Technical Service Information

MERCEDES 722.3 - 722.4 SLIPPING AND/OR NO REVERSE

Figure 1

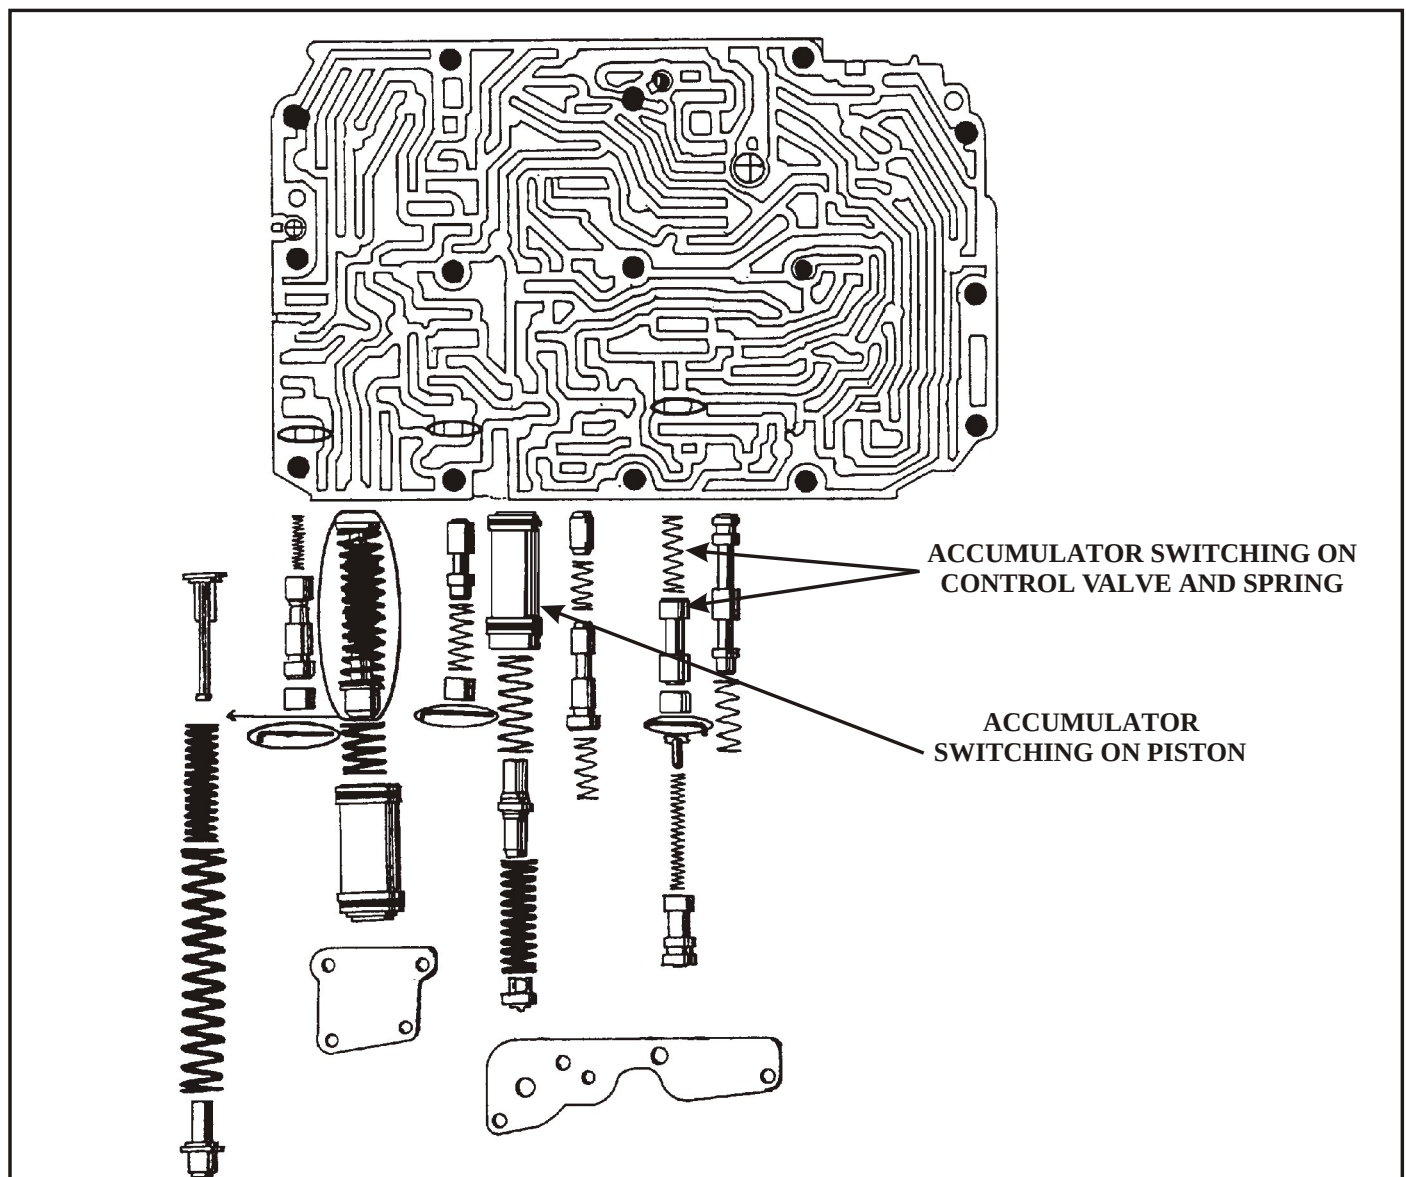
COMPLAINT: Before and/or after rebuild, any Mercedes equipped with the 722.3 - 722.4 transmission may exhibit a chattering in reverse, slipping in reverse, or no reverse.

CAUSE: The cause may be, a stuck or sticking *Accumulator Switching On Control Valve*, a collapsed or broken *Accumulator Switching On Control Valve Spring*, a missing, cut, or leaking seal ring on the accumulator piston, or a cracked *Accumulator Switching On Piston* (See Figure 1).

CORRECTION: Remove and disassemble the valve body. Inspect and replace as necessary, the parts and concerns listed above, as shown in Figure 1.
